## UNITED STATES PATENT AND TRADEMARK OFFICE

APPLICATION NO.	FILING DATE	FIRST NAMED INVENTOR	ATTORNEY DOCKET NO.	CONFIRMATION NO.
09/643,948	08/23/2000	Kaori Yasufuku	2423-6	9826
22204	7590 03/31/2003			
NIXON PEABODY, LLP 8180 GREENSBORO DRIVE SUITE 800			EXAMINER	
			FIGUEROA, FELIX O	
MCLEAN, V	A 22102		ART UNIT	PAPER NUMBER
		,	2833	
			DATE MAILED: 03/31/2003

#### **DETAILED ACTION**

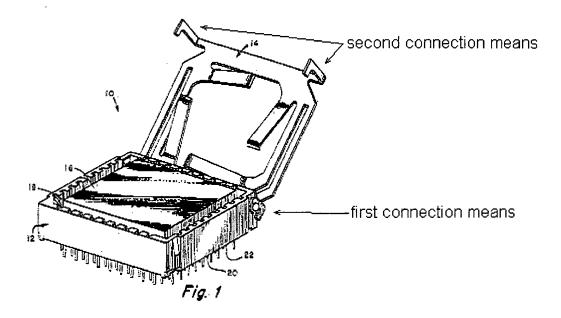
In response to applicant's arguments that Geib does not teach a metallic cover with "a first connection means for connection to a receiving part of the connector body,

and a second connection means for connection to a lateral supporting part of the connector body", see the following figure.
